# **Proposed World Headquarters of Jehovah's Witnesses Final Environmental Impact Statement (FEIS)**

This chapter of the FEIS summarizes the substantive verbal and written comments submitted on the DEIS. A preliminary submission of the FEIS was made to the Town of Warwick Planning Board on November 16, 2011, resulting in additional comments which are addressed herein. These subsequent comments are dated to differentiate them from earlier comments made on the DEIS. Complete correspondence from which these comments are drawn can be found in FEIS Appendix A.

**Figure 2-9 Architectural Rendering—Administration Offices/Services Courtyard View**

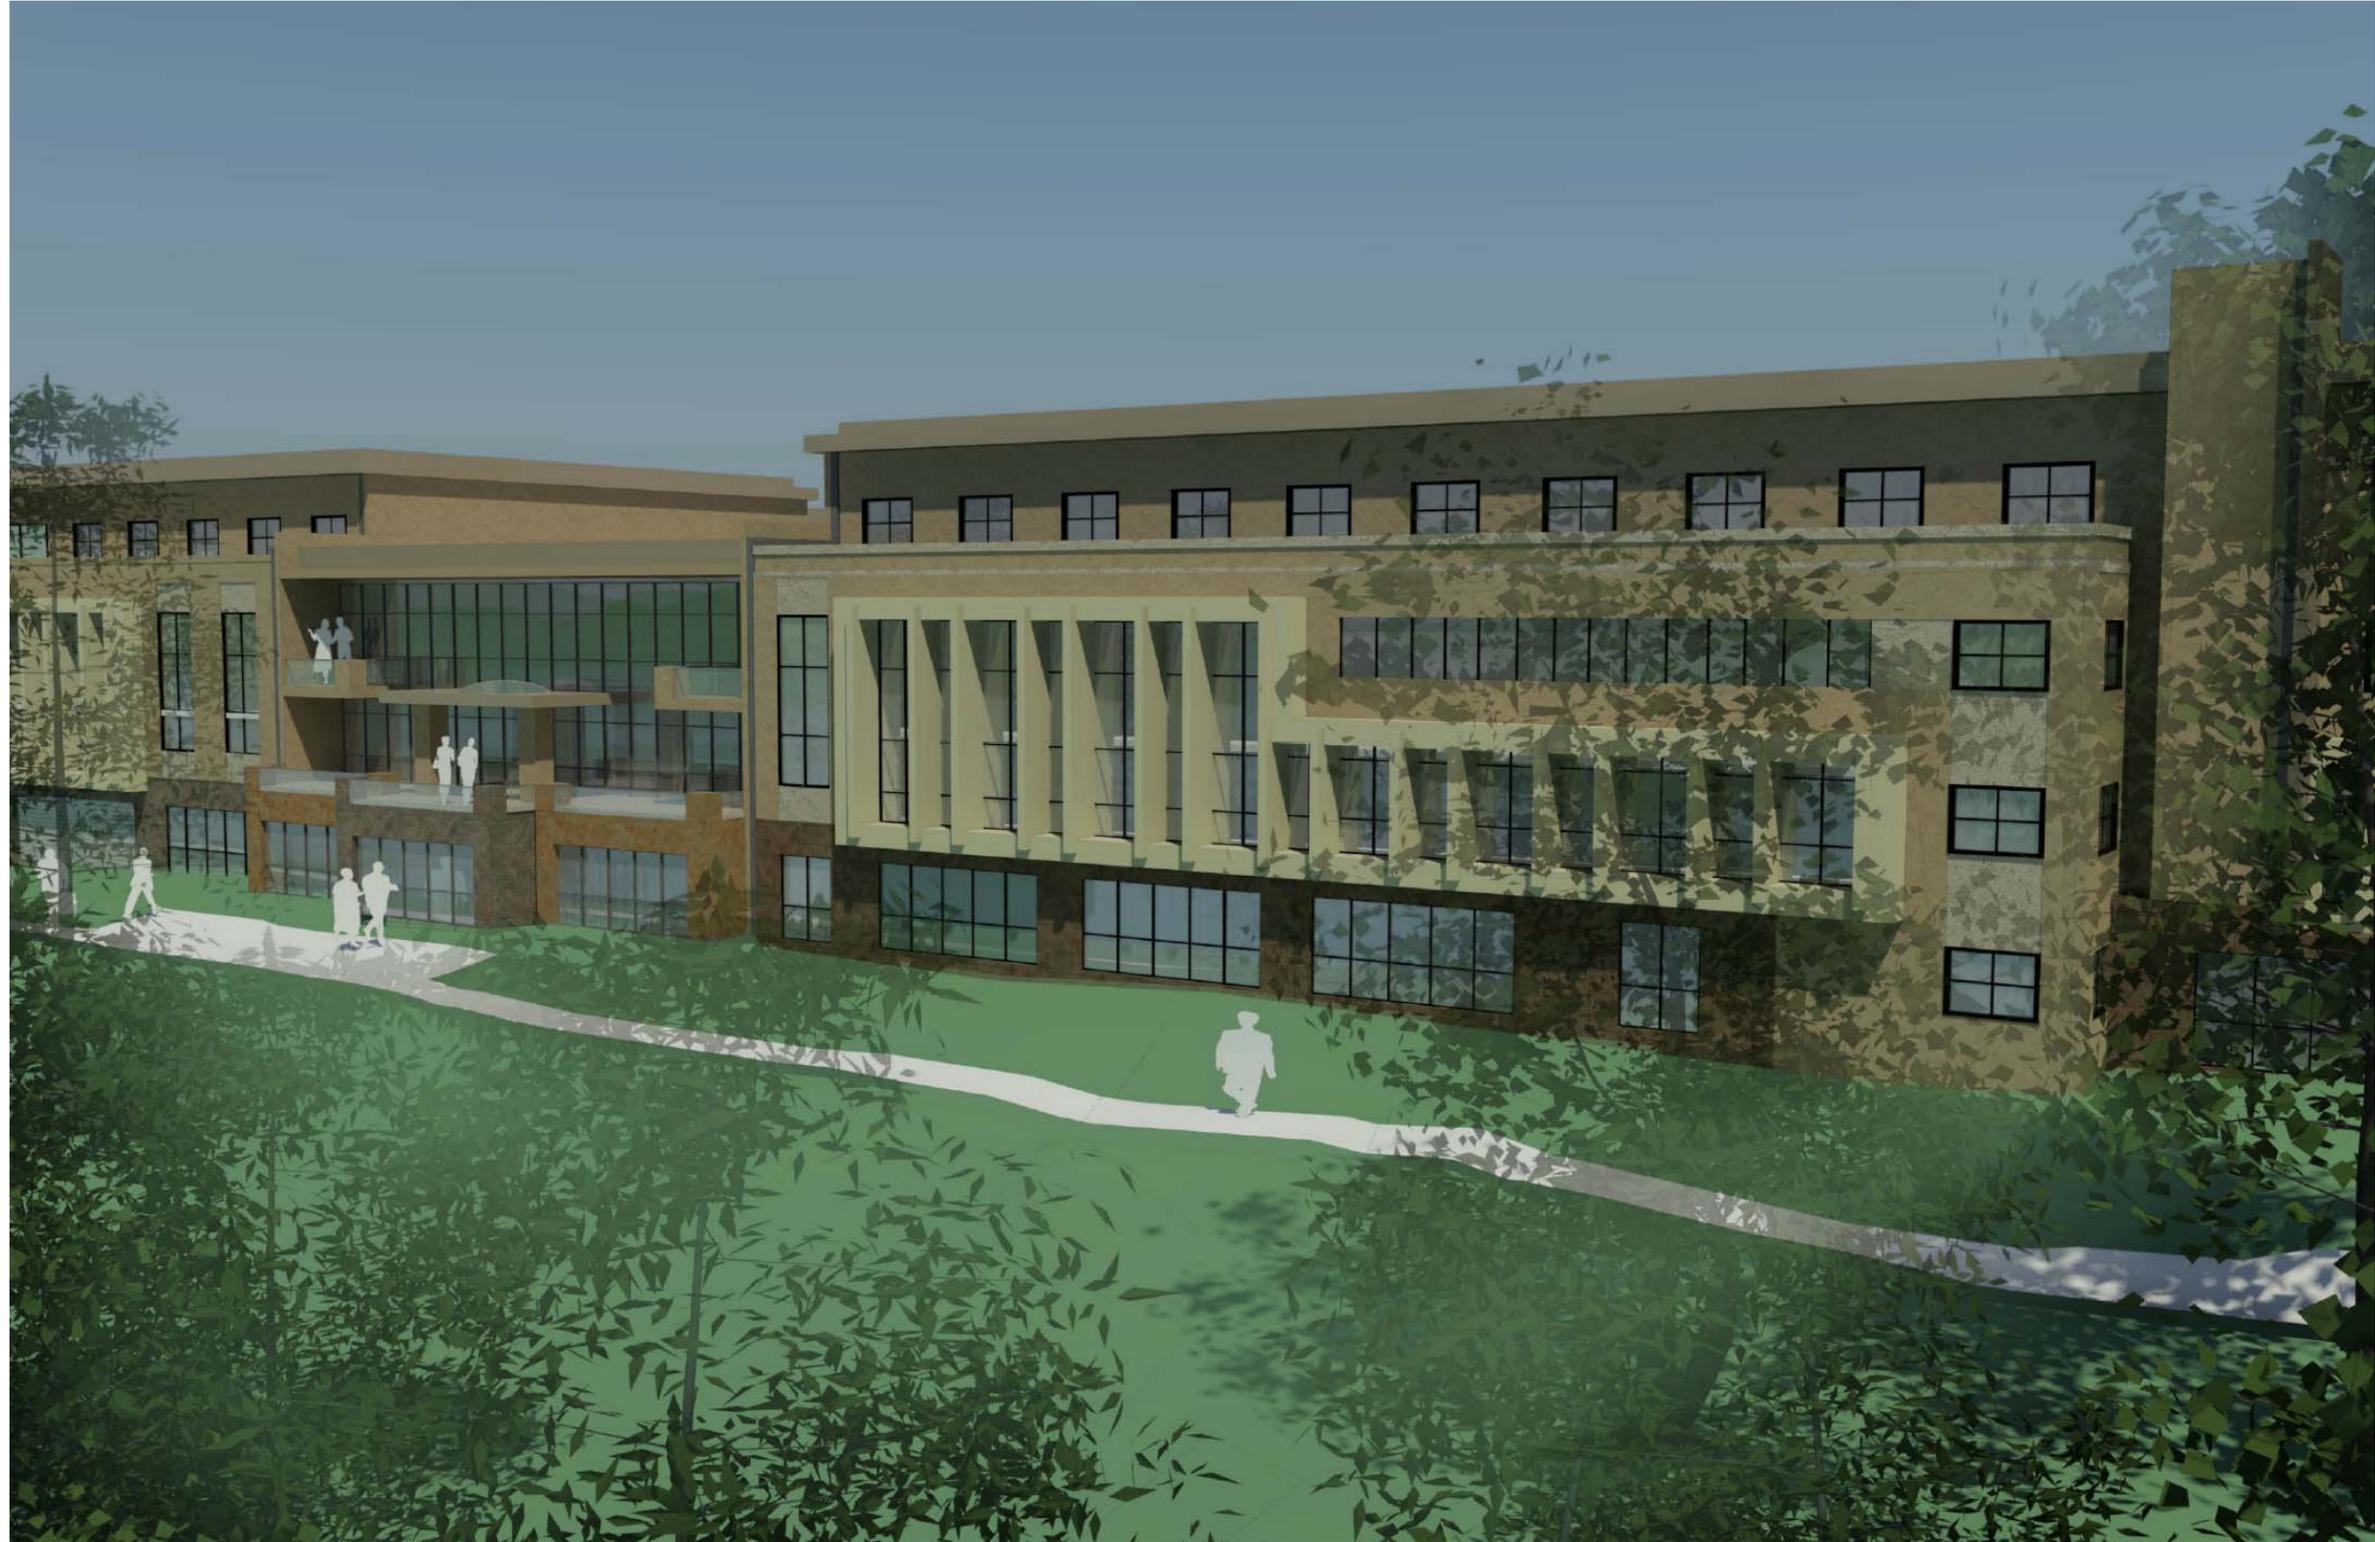
Page 13-24, first paragraph references Figure 2-6 as SWBP and 700' Ridgeline Overlay District. That is not the case, please update.

*Figure 2-9 Architectural Rendering—Administration Offices/Services Courtyard View and Figure 2-10 Architectural Rendering—Administration Offices/Services Lakeside View are reproduced in this FEIS for the benefit of those reading Chapter 13, "Visual Character." These renderings were previously provided in Chapter 2 of the DEIS, but were not referenced in Chapter 13. Newly provided renderings of the residence building and parking garage are included as Figures 13-35, 13-36, and 13-37.*
